2018/3223/P	35 Hillway N6 6AH	Erection of front porch; single storey side studio and rear extension (with green roof); erection of 2x dormer windows and hip to part gable roof extension to rear; formation of rear terrace at first floor level and installation of solar thermal panels to dwellinghouse following demolition of existing front porch and garage	Samir Benmbarek
-------------	----------------------	---	-----------------

Conservation Area Advisory Committee

Application ref 2018/3223/P

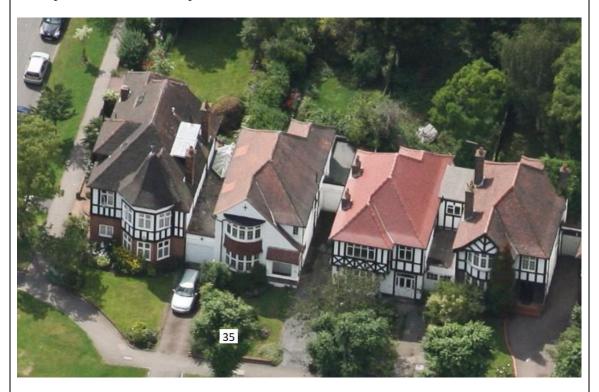
The proposed plans show long dormers on both the north and south sides of the roof and the extension of the ridge to the rear (west). Clearly visible from the photograph below of the existing roof are the areas where the original (3) chimney stacks have been removed sometime in the past, 2 on the south slope and 1 on the north.

As drawn the proposed drawings fail (a) – the tall chimneys, particularly that in the SE corner remains lost, (d) – the southern dormer is directly opposite a dormer on 33, and (g) – the sides of the north & south dormers are proposed to be glass, not tiles.

Extending the ridge & effectively creating a full height dormer is contrary to CPG1 which requires the ridge of dormers to 0.5m below main roof ridge (some of CPG1 was superseded in May 2018 but it is not clear which bits).

The northern dormer is overly long, prior to the adoption of the CAAMS in 2012 the HLE design guide stated that roof dormers should be wide enough to accommodate the stairs accessing the attic only and this has been applied since with the stairs being designed to minimise the dormer length. Although 33HW has a long dormer this is an original feature, the corner houses were 'statement' houses. A similar dormer is visible on 28HW.

The 'normal' positioning of the side dormer is on the north side as seen on the drawings in the Design & Access Statement, 55HW, 77HW, 81HW and 89HW. It is preferred side dormers are hipped (and possibly partially flat roofed) to reduce their bulk when viewed from the road. If light is required on the south side this is usually provided by high level conservation style Velux windows.

- North dormer, minimise length, sides to be tiled
- West dormer, to be 0.5m below ridge
- South dormer, refuse, possibly replace with Velux.
